HISTORIC DOWNTOWN ADVISORY COMMISSION
Village Green Municipal Building, Council Chambers
47 Hall Street
Tuesday, April 28, 2015
6:15 P.M.

1. ARCHITECTURAL REVIEW

Applicant: Sean Snyder
Location: Lincoln Street
Existing Zoning: DB, Downtown Business District
Request: To review a final development plan for a proposed two building office development on 1.05 acres at the request of the Planning and Zoning Commission.

Roofs (PAG, P. 285)

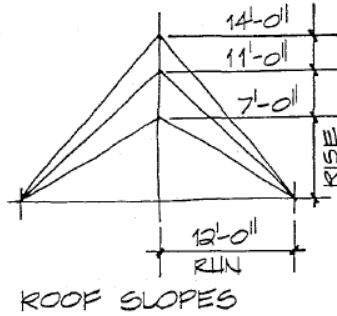
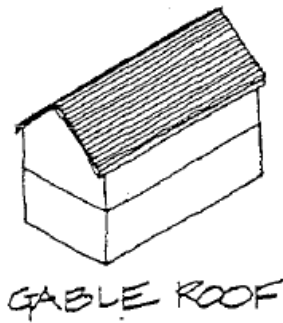
- The roof is consistent with the PAG. However, staff defers to the Architectural Advisor regarding slope.
 - For the larger building, the applicant is proposing a gable roof with a pitch of 12/4 for the main block of the building and 12/10 for the secondary block.
 - For the smaller building, the applicant is proposing a gable roof with a pitch of 12/5 for the main block of the building and 12/10 for the secondary block.
 - Gable roofs are most appropriate for new construction in the Historic District.
 - Based on PAG, the shape of the proposed building has an appropriate mass broken up by the porch.

350 MEDIUM STILE

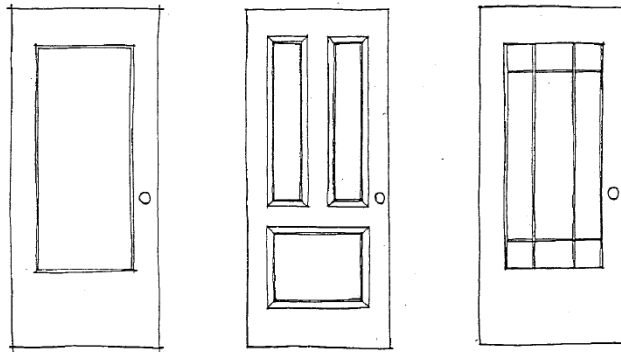
- The applicant's doors are in line with some of PAG recommendations.
 - Although wood doors are preferred, steel doors may be appropriate for replacement or new construction.
 - Staff defers to the Architectural Advisor for an opinion on the details of the door.
 - The PAG does not have guidelines regarding garage doors.
 - Staff defers to the Architectural Advisor for an opinion on the garage doors.

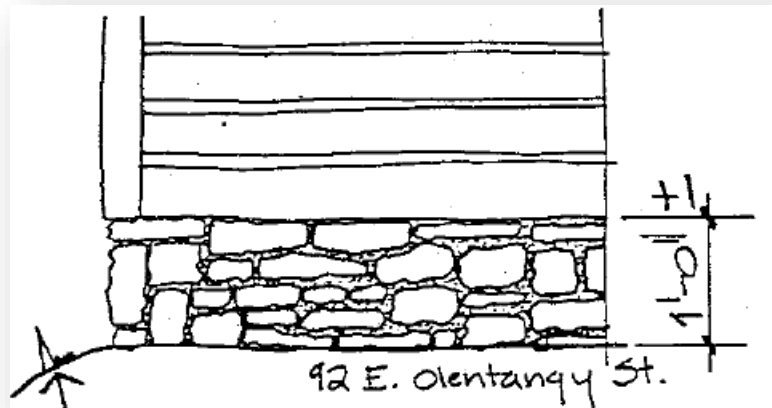
7. The applicant provided turning radius analyses for 40 and 53 foot trucks. To do a rough analysis, staff took the diagrams and superimposed them onto aerial imagery using GIS (the images are attached). Staff, along with the Acting City Engineer did a cursory examination of the images and determined the following:

- a. The Lincoln Street sides at West Olentangy Street will need to be improved to accommodate truck traffic. Improvements would include widening the throat and radius, moving the sidewalk back, possibly relocating the utility pole and restriping. Further details would be determined at a later date by the City Engineer if the plan were to be approved.

- b. A "Semis no right turn" sign will need to be installed to restrict turning onto Lincoln Street for westbound trucks.
 - c. Staff also determined that in the long-term, Lincoln Street may need to be widened and improved due to increased traffic and the development of the adjacent sites to the west and east and south of the subject site. At this time, however, the improvements are not necessary. Since this parcel is in the TIF district, if approved, the property development will increase the TIF fund that could ultimately be used to make the improvements. The neighboring vacant sites, when improved, would also pay into the TIF fund, which would

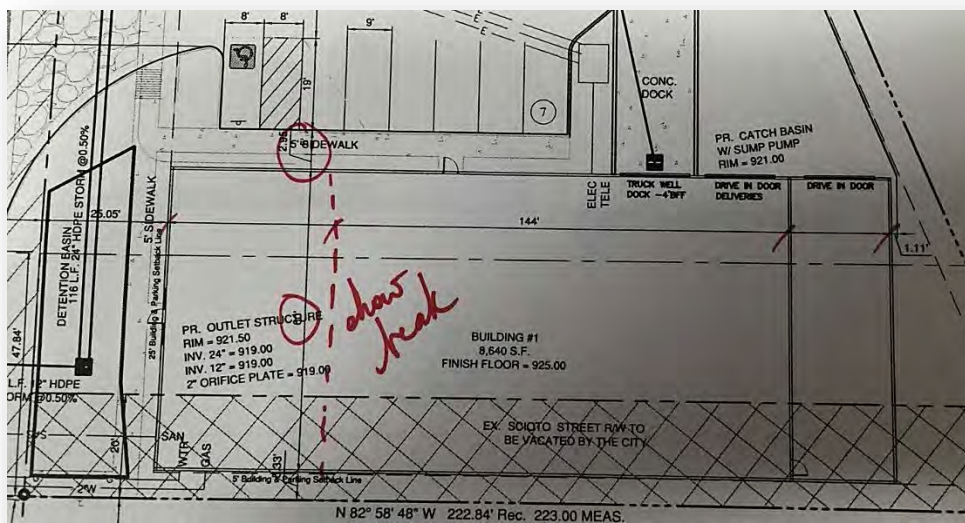
8. The applicant provided additional elevations for Building #1. After reviewing the new architectural drawing staff has the following comments:
 - a. The window style may need to be changed. As per the Architectural Guidelines, double hung windows with no grids are preferred. Also, the dimension of the windows may be incorrect. Dimensions of windows should also be reviewed in the Architectural Guidelines.
 - b. Staff suggests adding a small, stone veneer foundation to the bottom of each proposed building. Stone foundations are typical for barns, the style these buildings are aiming to mimic (see example below).

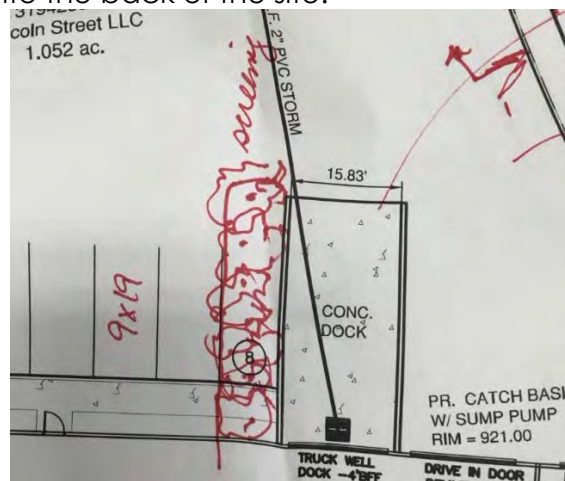
1. The number of parking spaces is insufficient. The applicant used *warehouse* parking requirements (1 parking spot per employee) in their calculations however, the appropriate requirement is for *office use* (1 parking space per 200 square feet). As a result, the site requires a total of 15 parking spaces, not 11. Staff suggests putting additional parking spaces along the back of the site (see below).

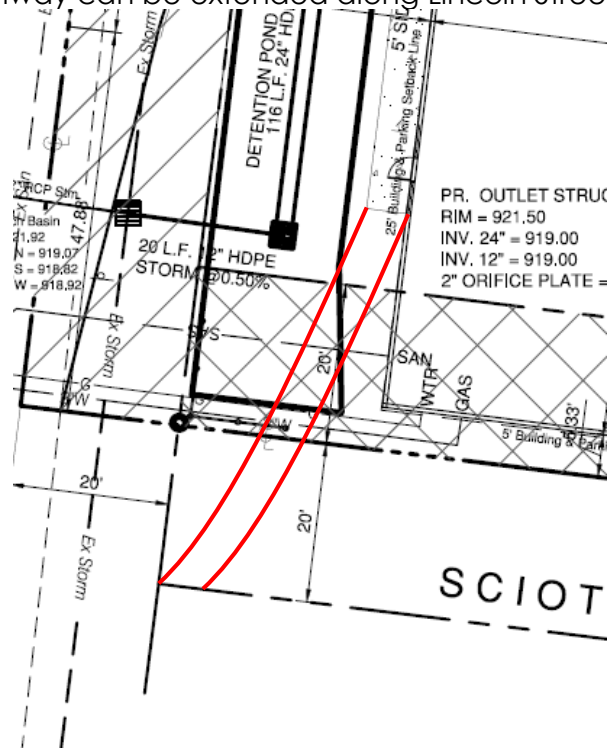
2. The loading dock needs to be screened. Staff suggest removed a parking space and using the space to screen the loading dock (see below). The removed parking spot could also be added to the back of the site. Staff determined that the 4 spaces above and the 1 space here could easily be fit into the back of the site.

FIGURE 2 – ALTA Survey

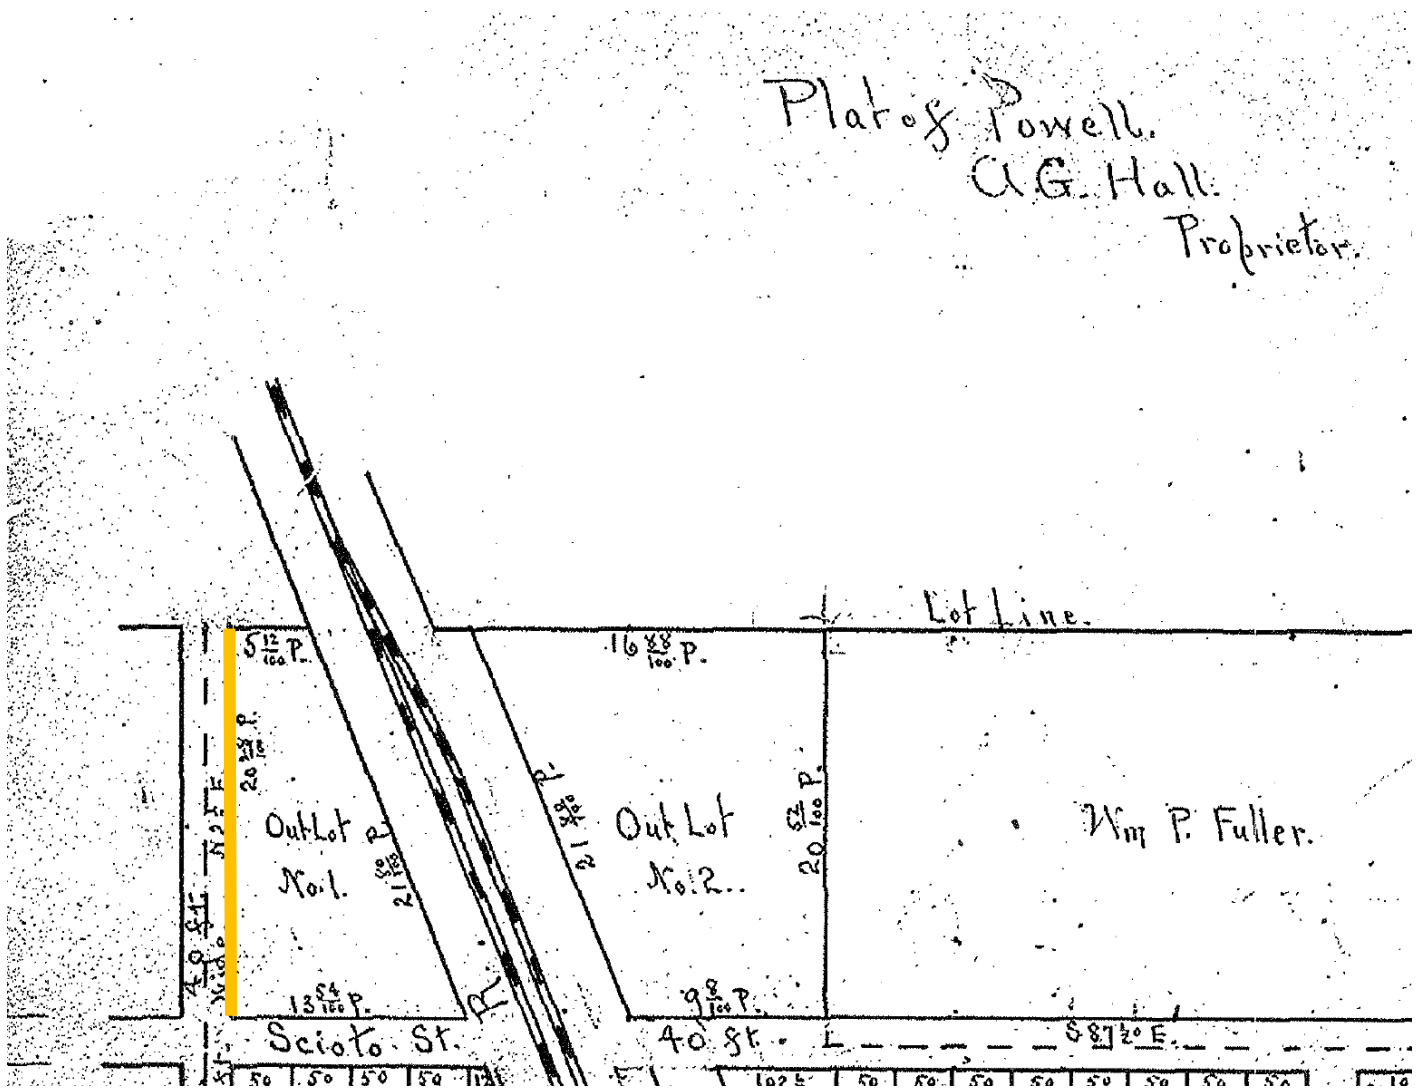
The proposed development is located in the Downtown Business District. Staff reviewed the rules and regulations of the Downtown Business District and found that the development is generally in line with its requirements. There is however, an issue with the survey as presented. Currently the survey may incorrectly show the property edge of the site at the road centerline (see Figure 2, see blue line). Staff did some research and found that the property line may actually be further back at the edge of the right-of-way (Figure 2, see orange line). Staff will need a correct survey to determine the appropriate setback requirements. As of now, Staff assumes the 20 foot setback requirement from the edge of the right-of-way line (Figure 3, see red line), which would then require the applicant to receive a front yard setback variance. Nevertheless, this can be determined at the preliminary development plan stage of review.
